ADDENDUM NO.1 - Mercedes Sports Park – Phase 1

DATE: Tuesday, December 11, 2018

JOB No. 2017-019

L4

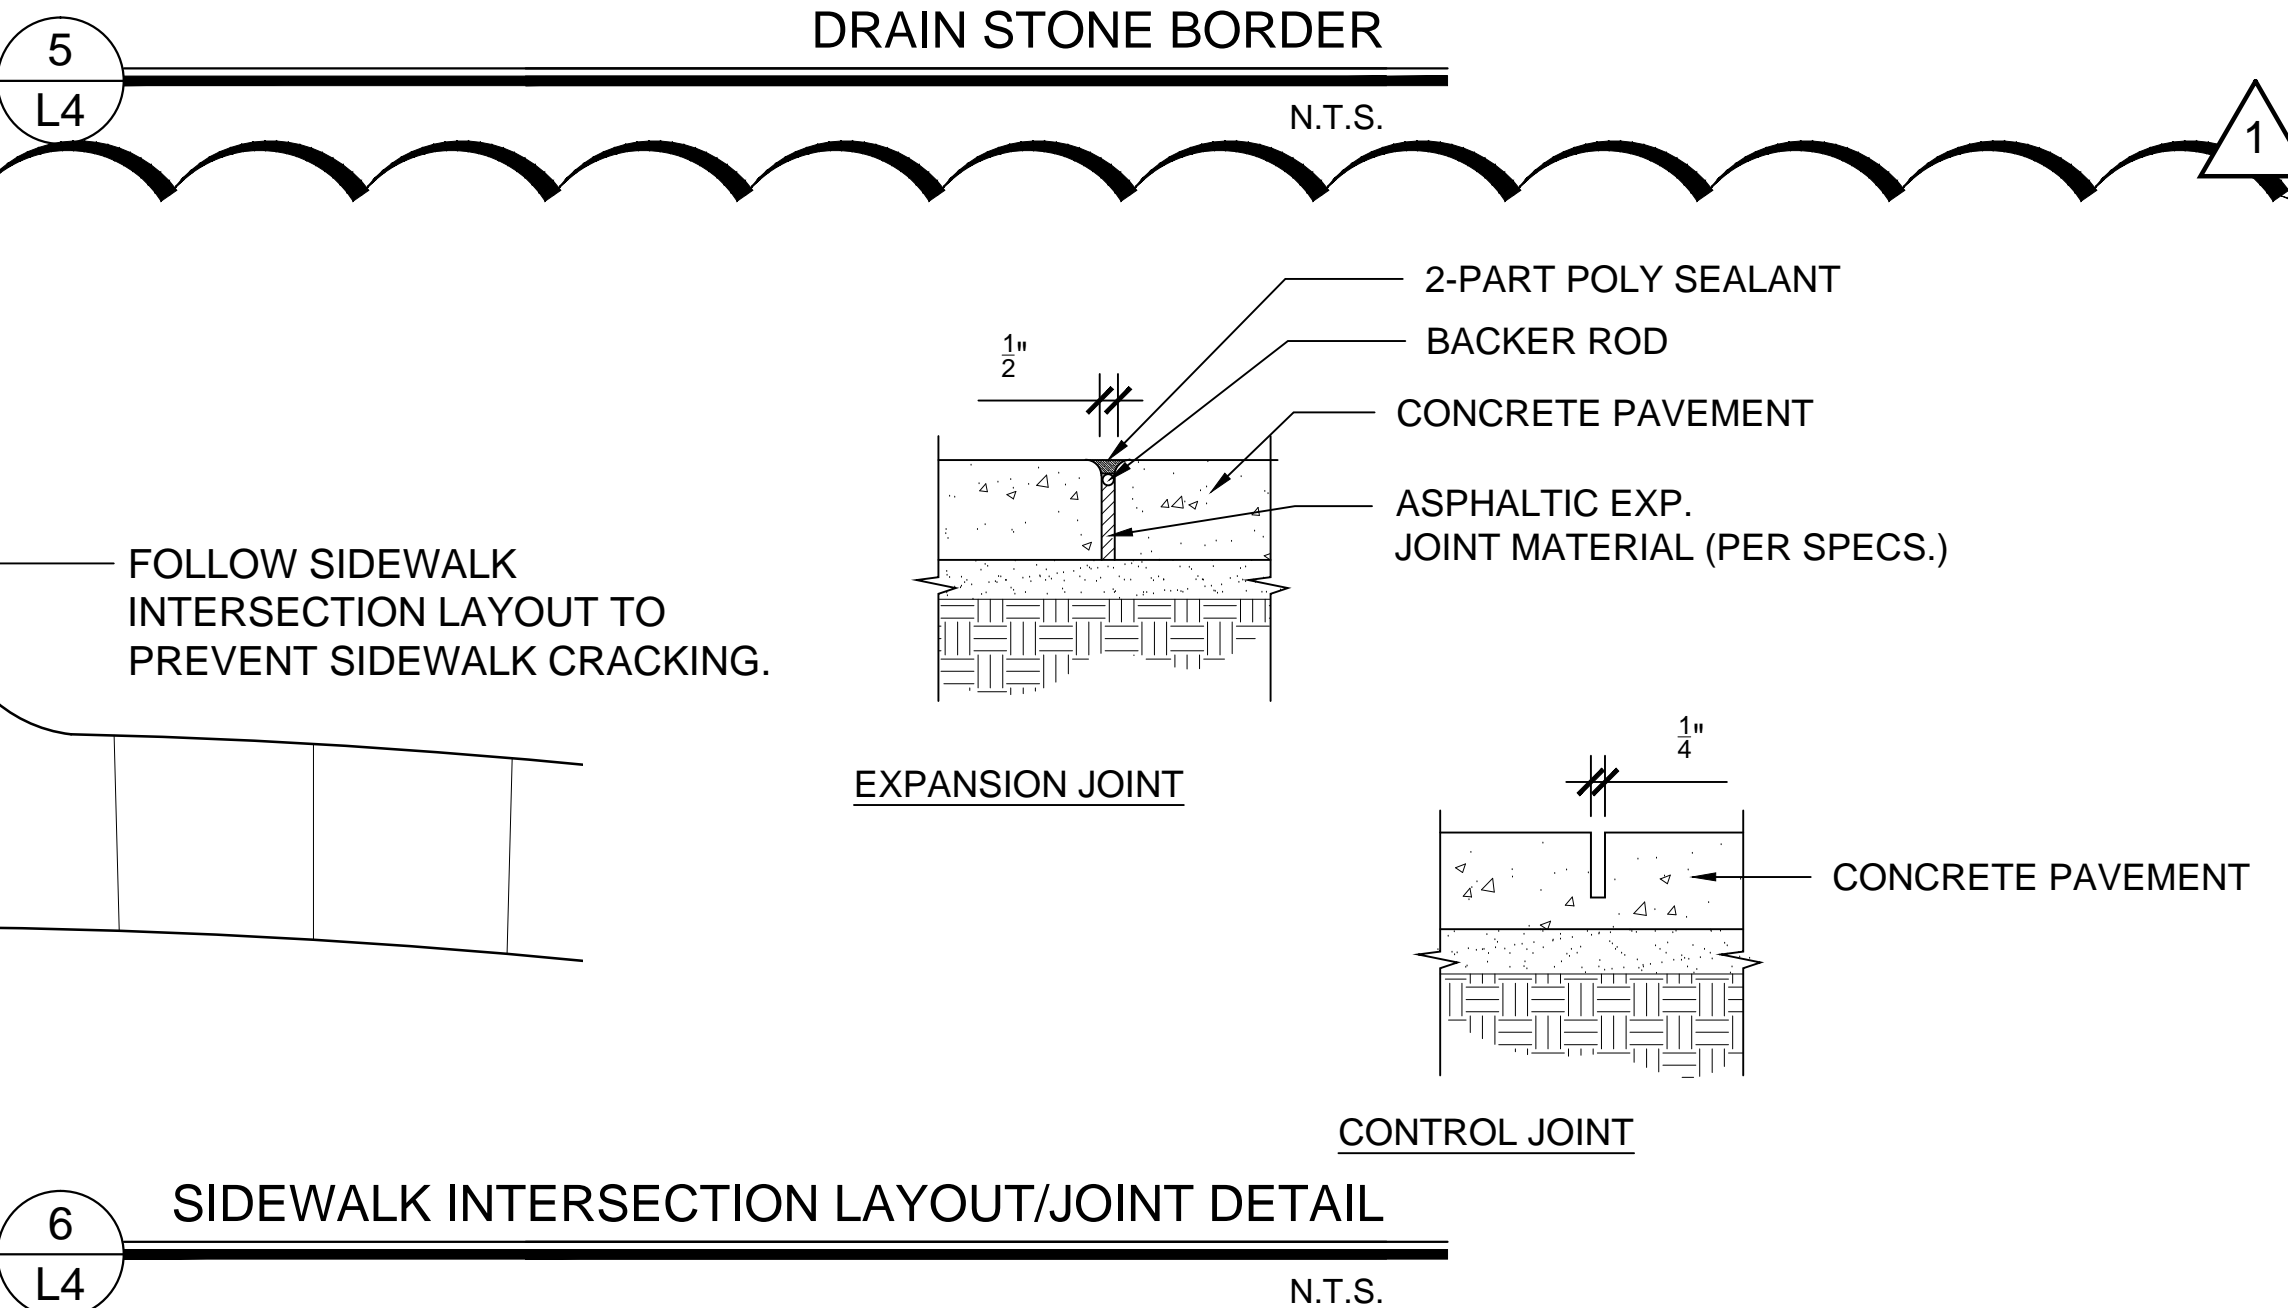
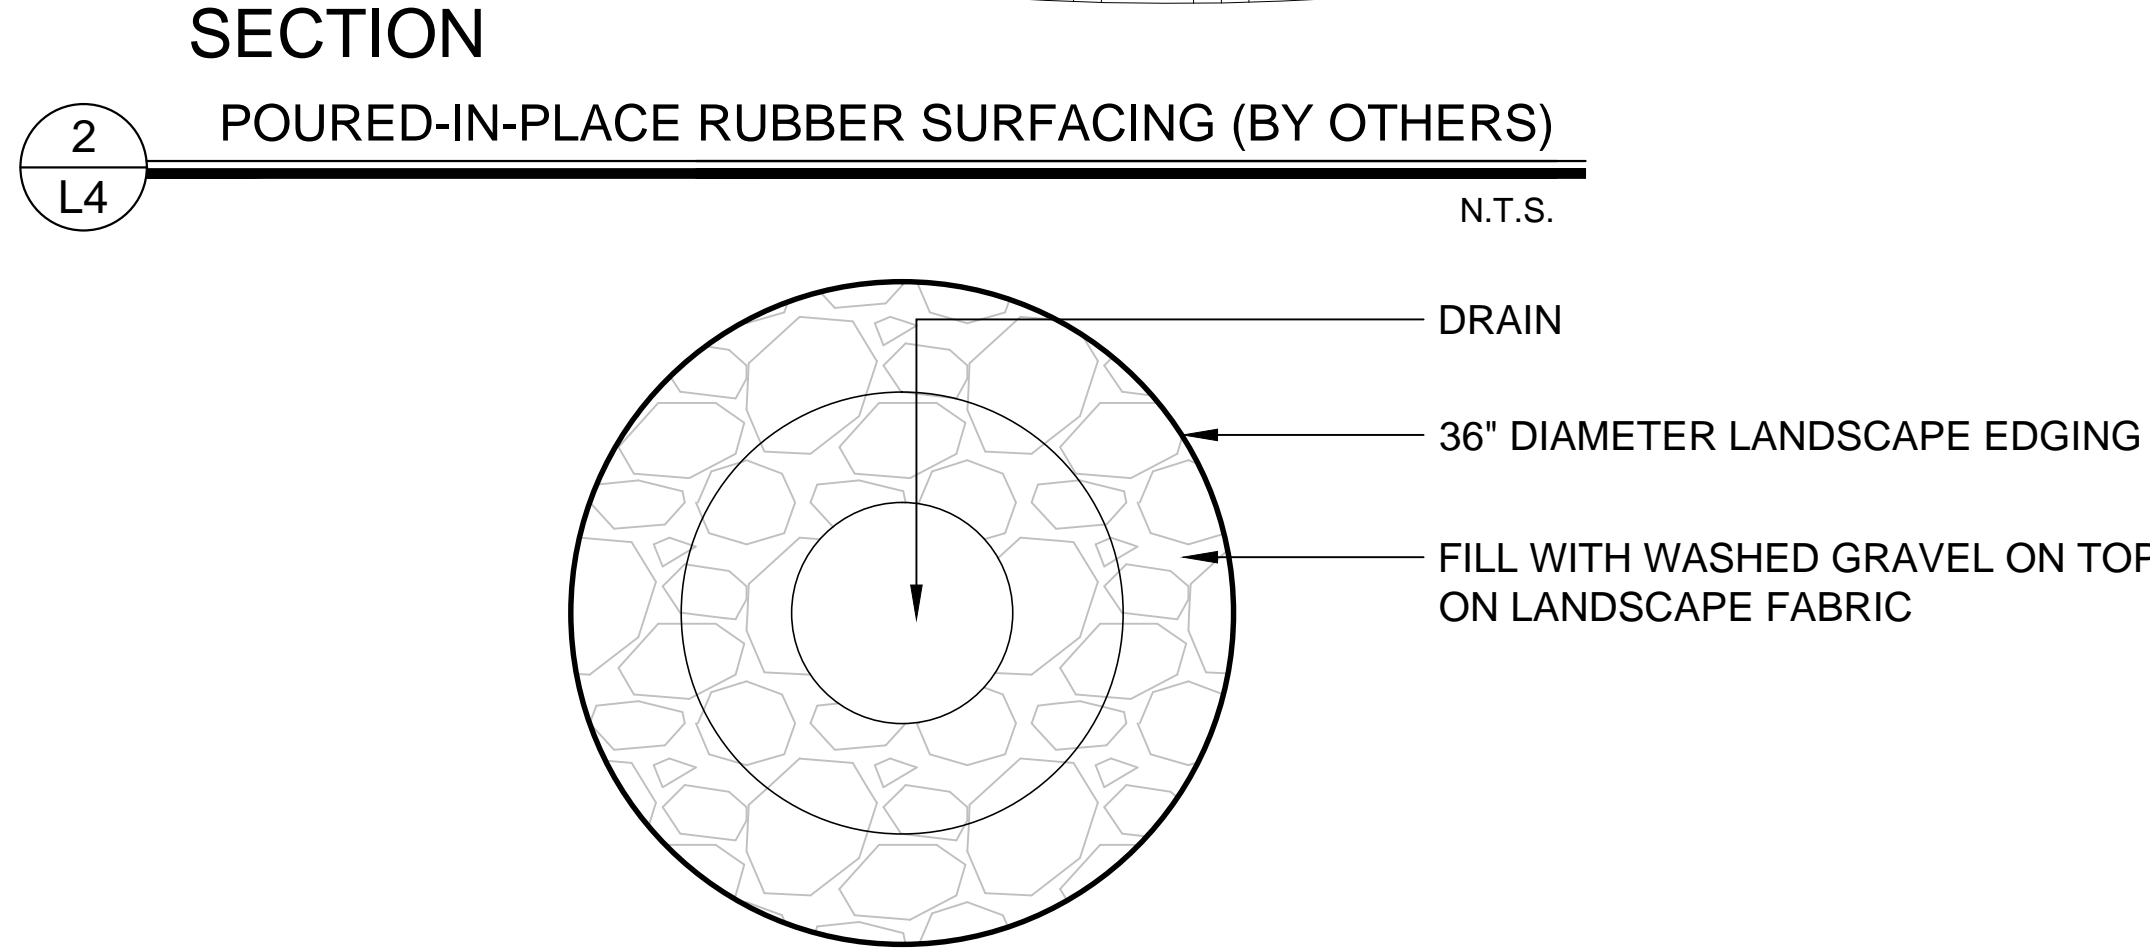
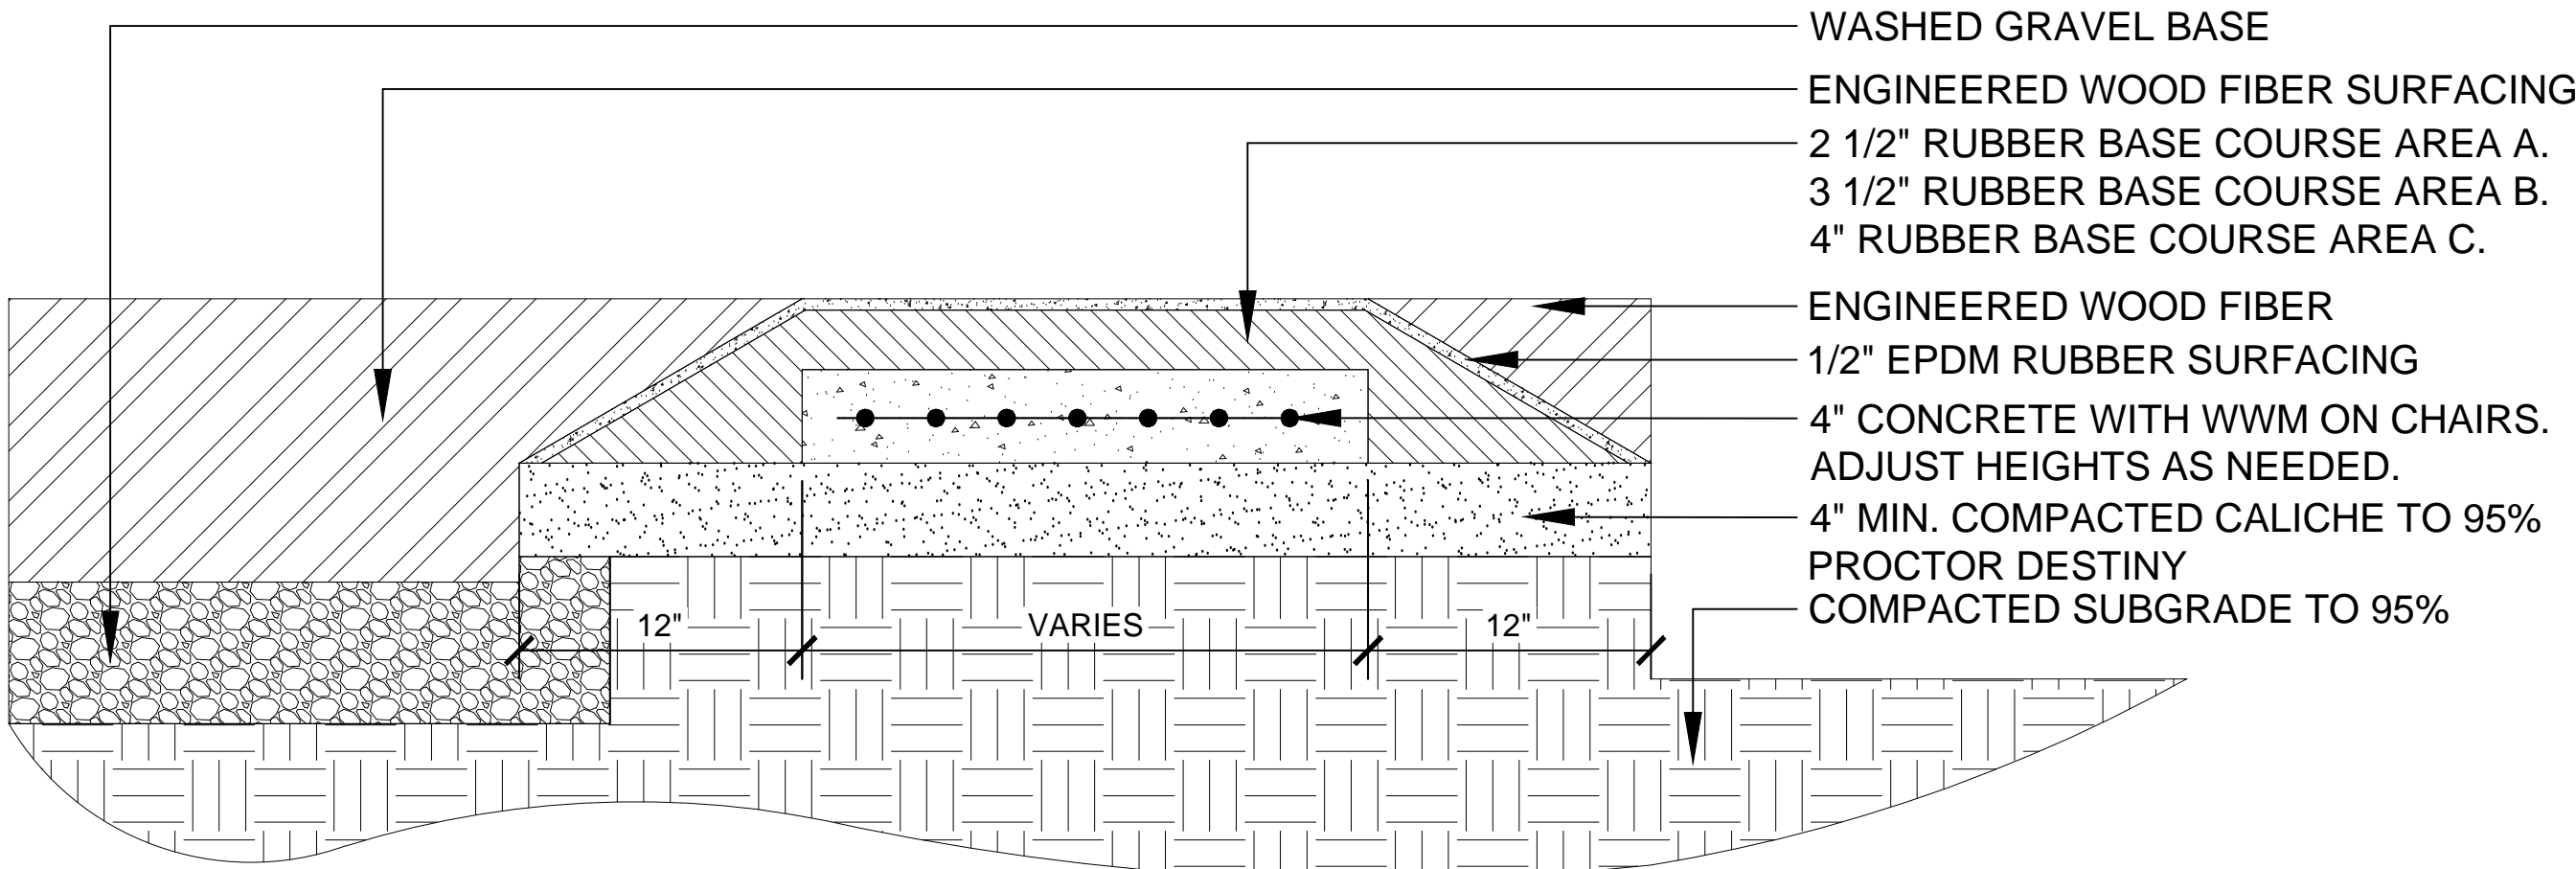
- A. See attached Landscape Addendum items. (12-8.5x11), (2-24"x36")
Sheet L2: Added a note for sidewalk intersections, this note will refer you to detail 6/L4.
Sheet L4: Added sidewalk intersection layout detail for control/expansion joints to reduce concrete cracking.
Per attached, add Specification Section 328400 NON-Potable Planting Irrigation. This Spec Section is for the harvesting tank irrigation system use only.
